**STATE OF NEW HAMPSHIRE
INTER-DEPARTMENT COMMUNICATION**

SUBJECT: Dredge & Fill Application (UPDATE 1)
Wakefield, M312-13
DES File #2017-01738

Minimum Wetland Application
 M-312-13
 10 Scale
 2/10/17
 By: L. Evans
 Revised by S. Large
 6/26/17

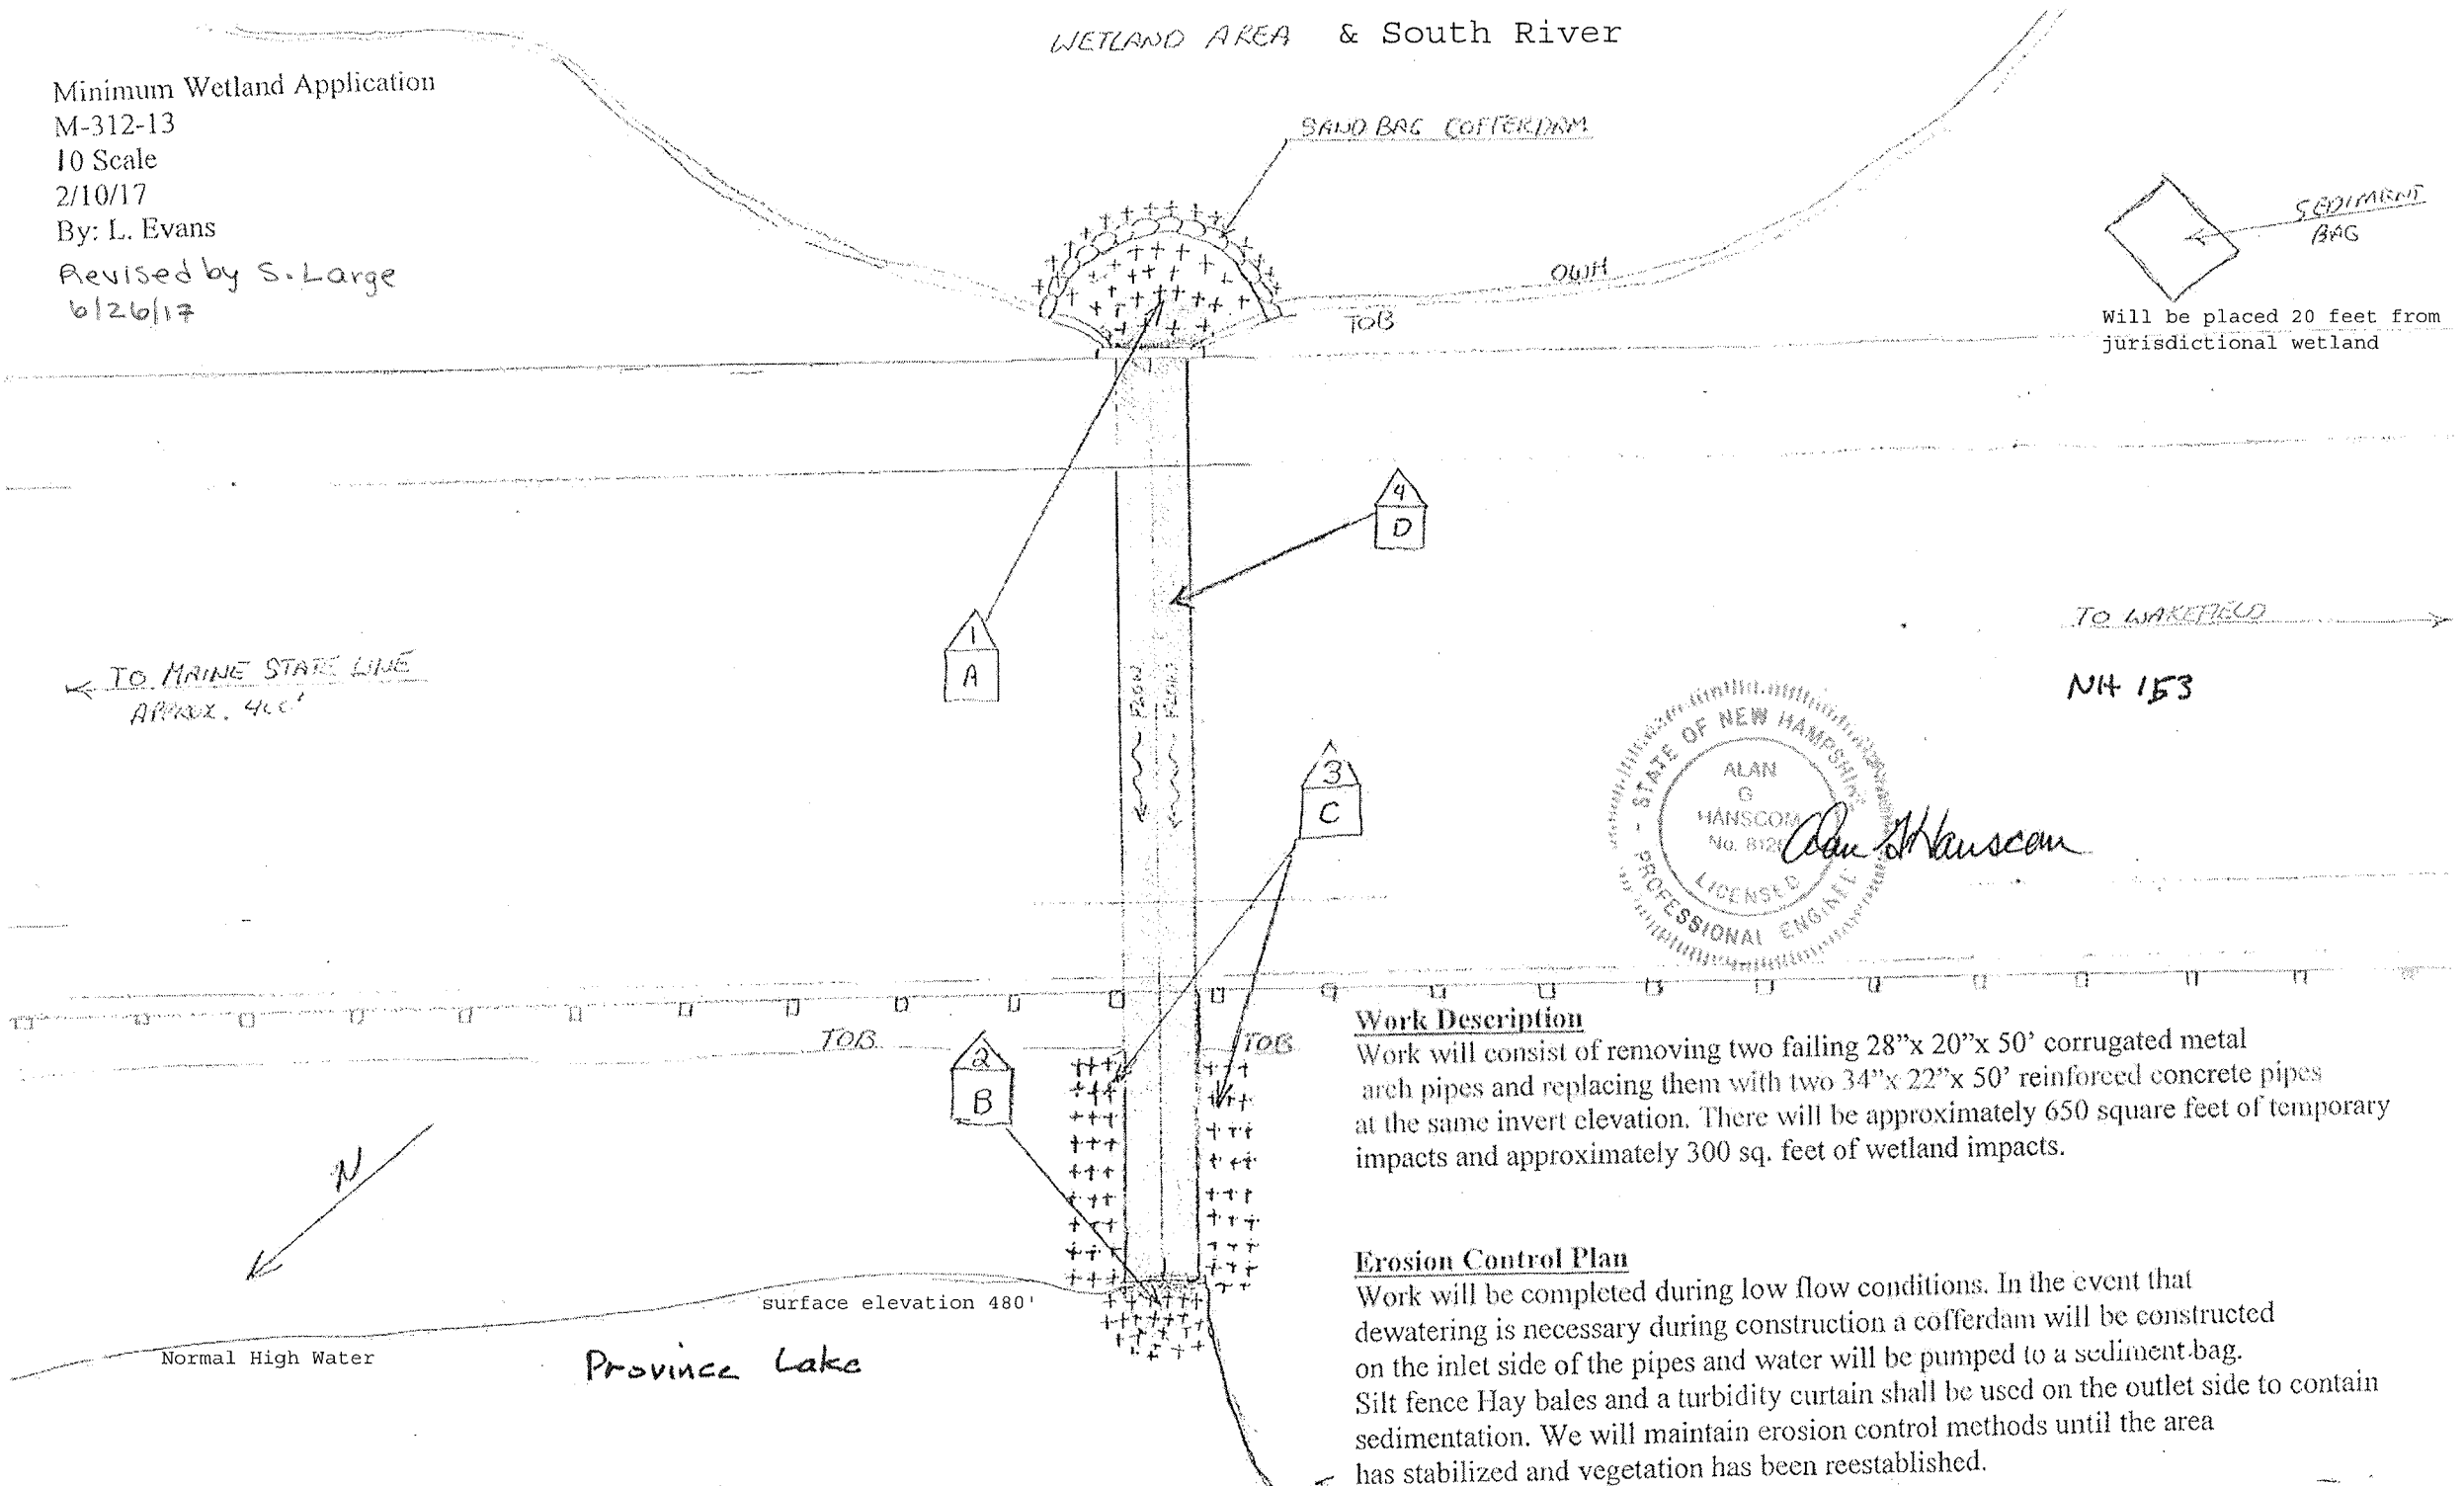
Forwarded herewith is an update to the Wakefield M312-13 (DES permit #2017-01738) Application package that was submitted on 6/16/17. The need for this update is a result of the matter that District 3 is unable to order the originally proposed 28"x20"x50' twin polymer coated steel arch pipes. District 3 is now proposing to increase the size of the pipes and use 34"x22"x50' reinforced concrete twin pipes. The concrete pipes continue to serve the goal of replacing the culvert with a longer lasting material at this crossing. The increase pipe size will provide a slightly larger hydraulic capacity through the crossing carrying flow from South River into Province Lake. This change in pipe size has increased the impacts by 75 feet, which equates to \$15.

R2UB3: **550** sq. ft. temporary impacts (was previously 475 sq. ft.)

Total impacts: 950 sq. ft. (amount increased by – 75 sq. ft.)

Work will consist of removing two failing 28"x 20"x 50' corrugated metal arch pipes and replacing them with two 34"x 22"x 50' reinforced concrete pipes at the same invert elevation. There will be approximately 650 square feet of temporary impacts and approximately 300 sq. feet of wetland impacts.
